4829 MT OLIVE CHURCH RD

INDIVIDUAL WATER AND WASTEWATER SYSTEMS PROGRAM
APPLICATION FOR SERVICES

Mecklenburg County Health Dept.
Environmental Health Division
c/o Hal Marshall Ctr., Suite 211
700 N. Tryon St.
Charlotte, NC 28202
(704)336-5102 file # 3141A

An inspection was made at the property located at 4829 Mt. Olive Church Road, Charlotte, NC to facilitate the issuance of an Operations Permit for the sewage treatment and disposal system. During the inspection it was found that the following items did not meet the regulations set forth in the "Laws and Rules for Sewage Treatment and Disposal Systems, 15A NCAC 18A .1900; 1952 Septic Tank, Dosing, Dosing Tank and Lift Station Design." Our comments follow:

PROPOSED PLOT PLAN

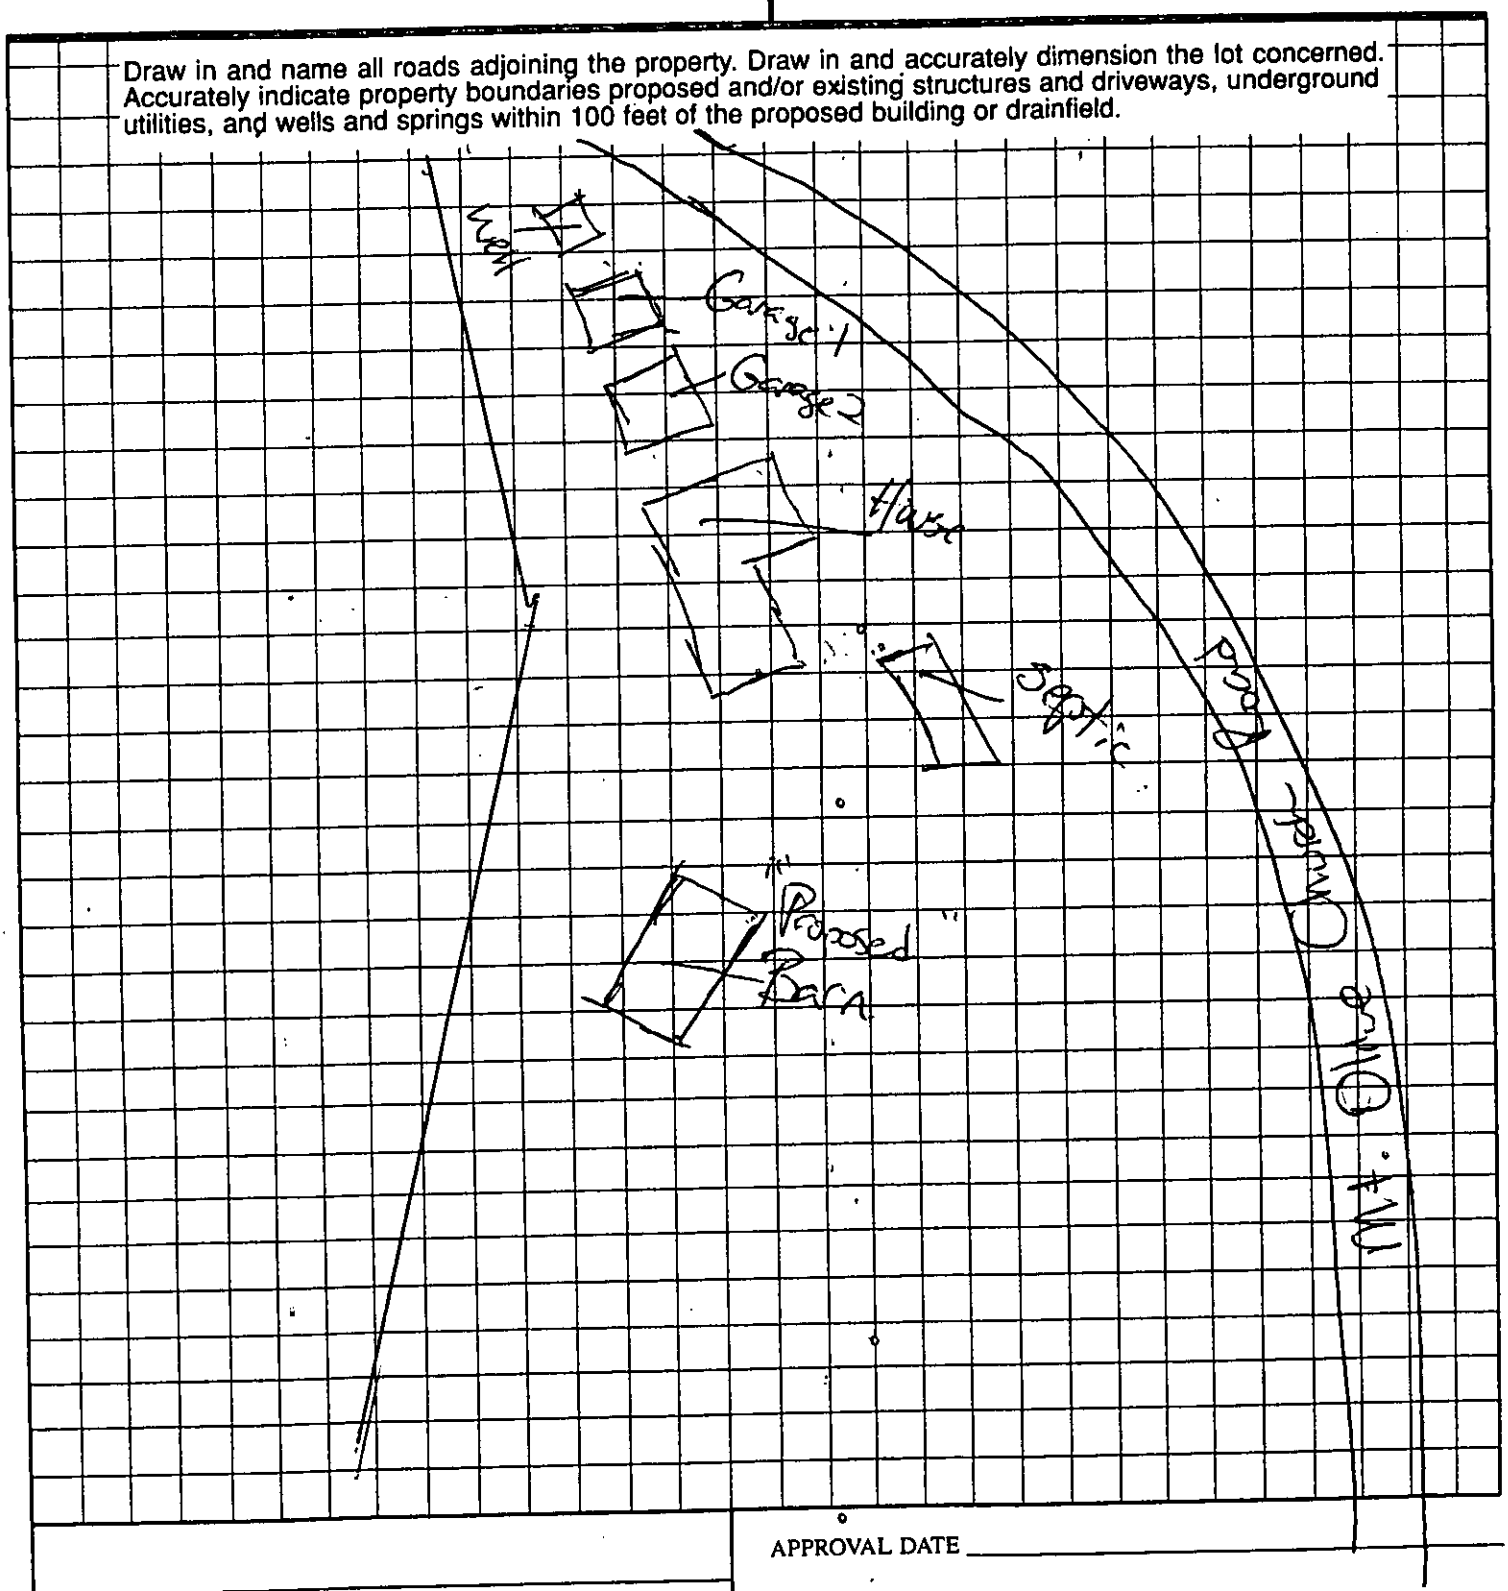
...System is ok for barn construction.

PROPOSED PLOT PLAN

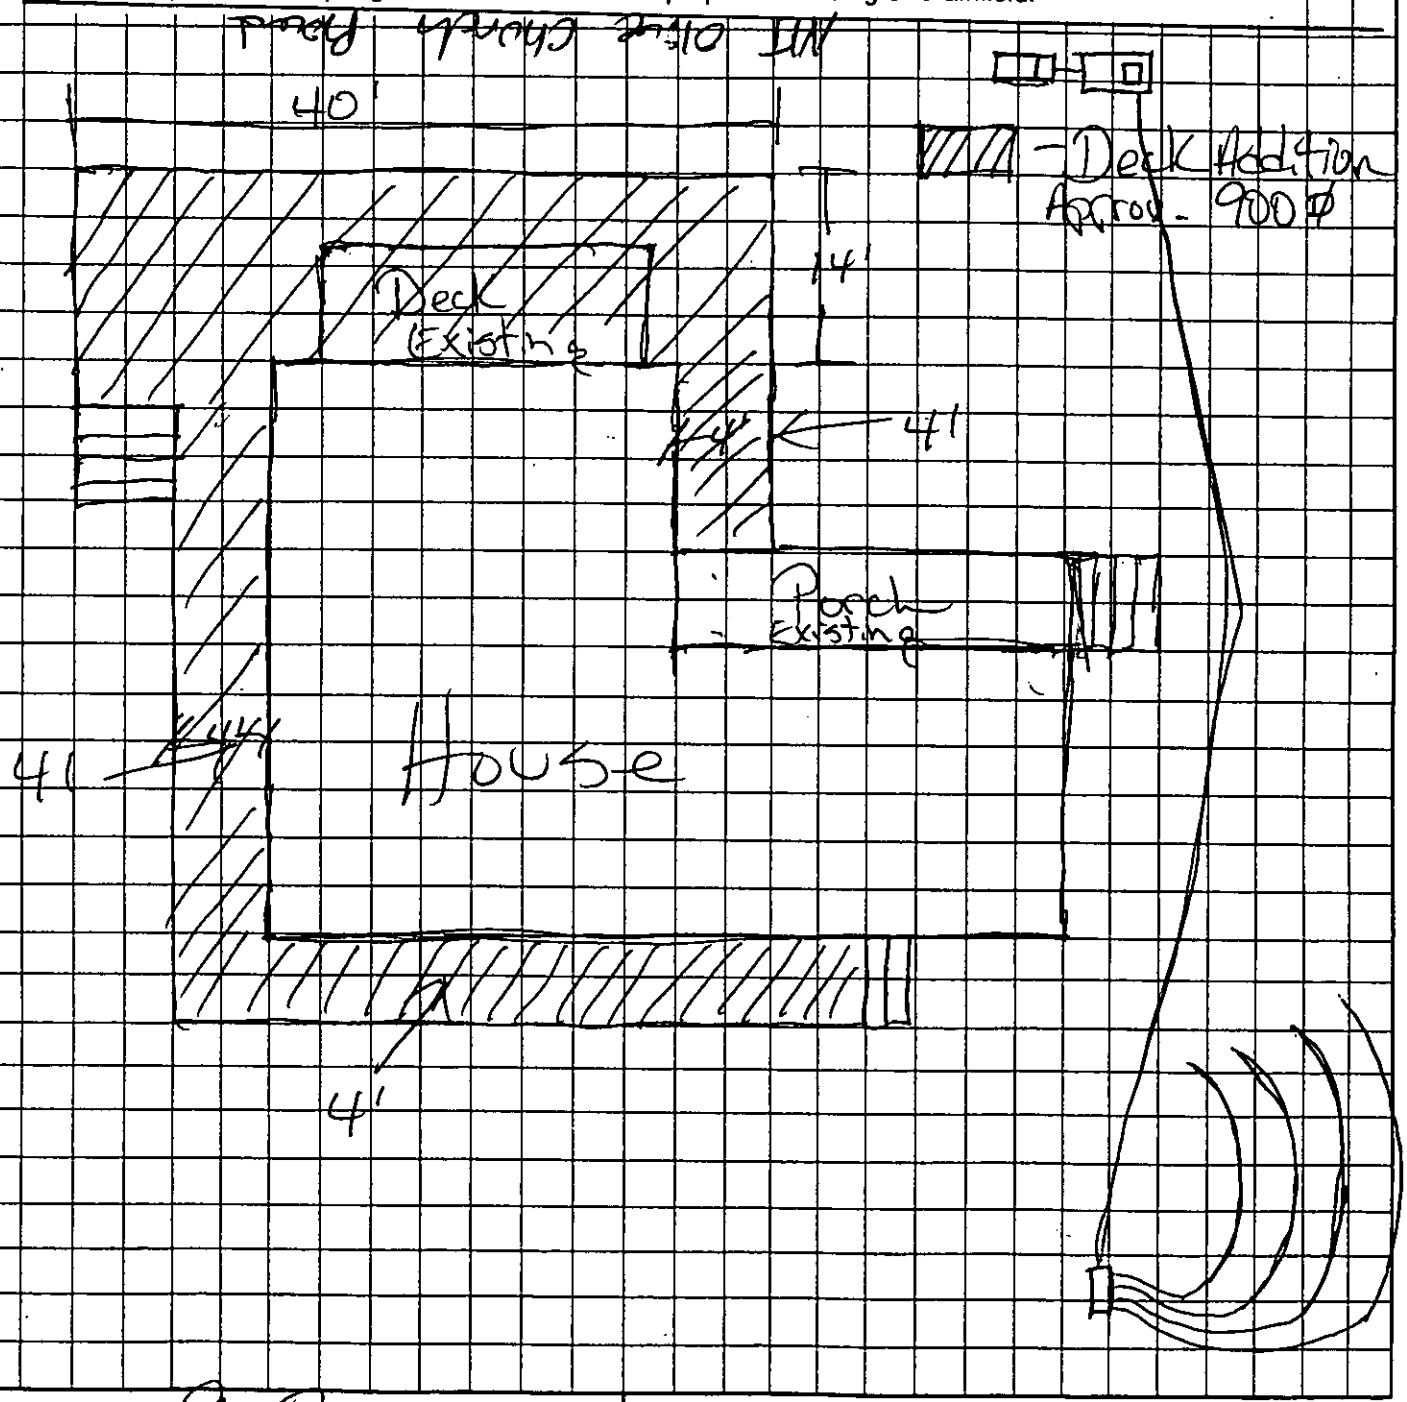
...System is OK to use for Deck ___ addition. Stay 5' from septic Tank

PLOT OF SYSTEM

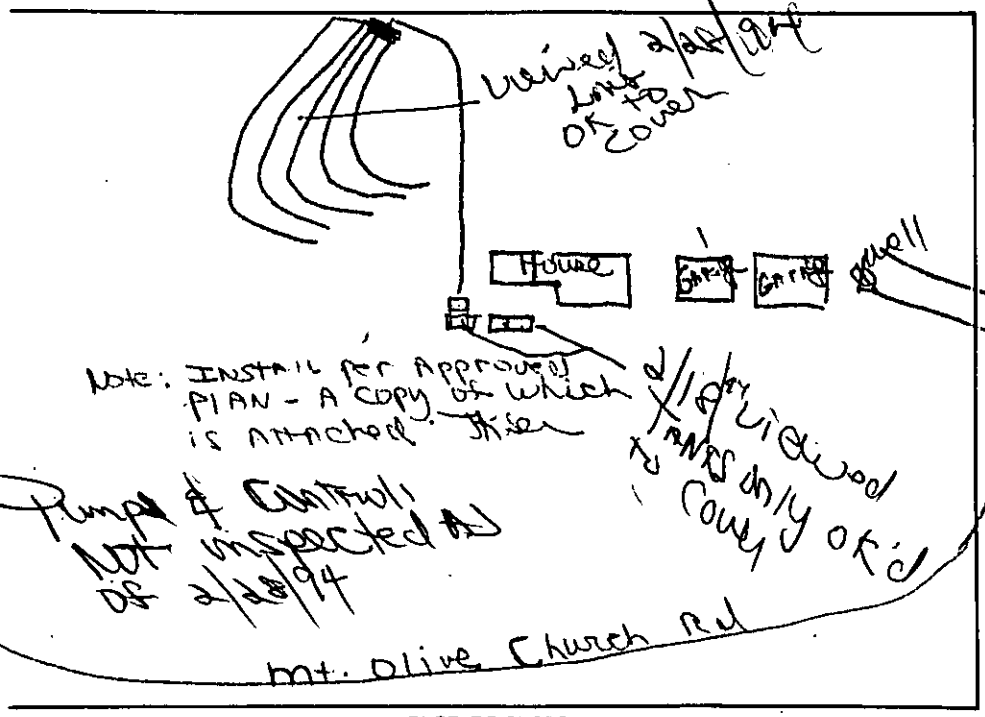
Comments: INSTALL per Approved plan. Shallow Trench System Keep Line installation Shallow at 18" - 12" Stone 6" Cover - System uses Pressure Manifold - See detail drawing and Hydrotronics pump SPF 50/2 5 trenches 3' x 80' x 12" Stone - 18" depth

PLOT OF SYSTEM

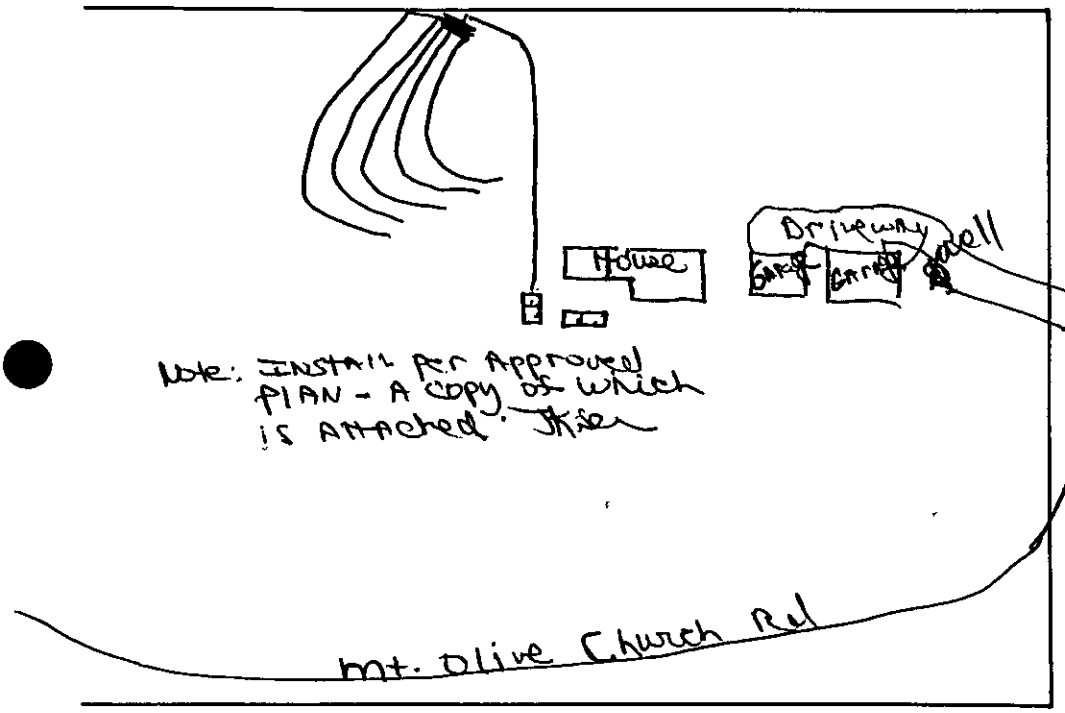
Note: INSTALL PER Approved PLAN - A COPY OF WHICH IS ATTACHED. JKR

Comments: INSTALL per Approved plan. Shallow Trench System Keep Line installation Shallow at 18" - 12" Stone 6" Cover - System uses Pressure Manifold - See detail drawing and Hydrostatic pump SPS 50 5 trenches 3' x 80' x 12" Stone - 18" depth
